DECEMBER 18  
TAP110

## FORD PX3 RANGER & EVEREST 06/2018-ON TOW POINT INSTALLATION - RP-RAN02

Applicable to vehicles manufactured post JUNE 2018.

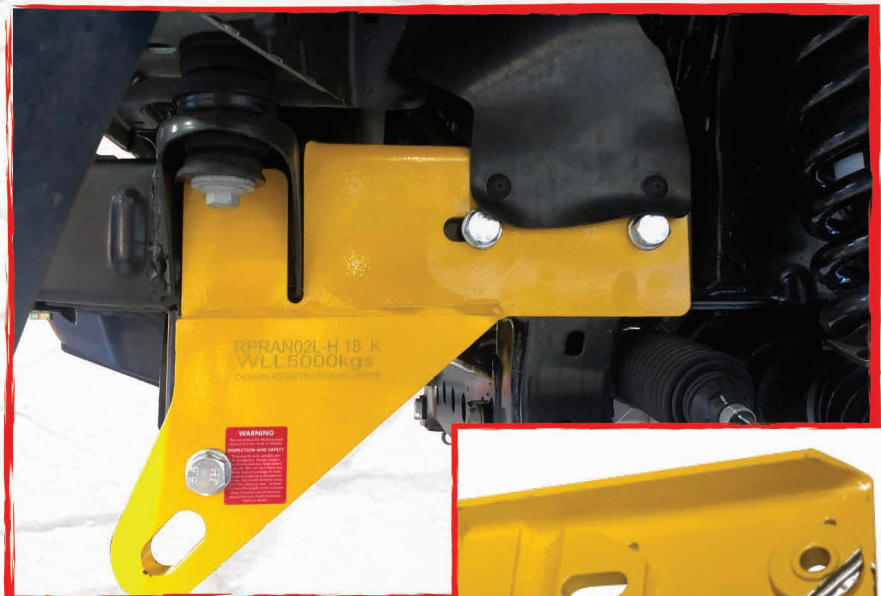
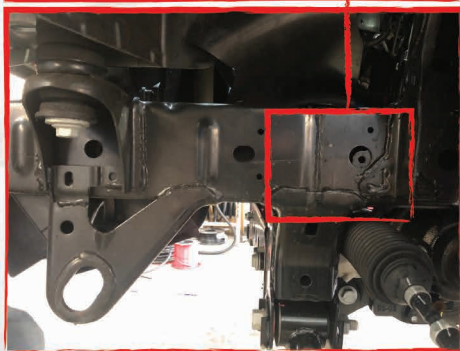
A stiffening plate installed inside the chassis rail affects access to one hole used in the fitment of RP-RAN02 (Refer Image). Using a step drill enlarge this hole to allow fitment of the supplied hardware. The spacer pictured will require modification to clear the new weld not present on previous vehicles.

The nut plate will sit behind the stiffening plate, with the bolt passing through.
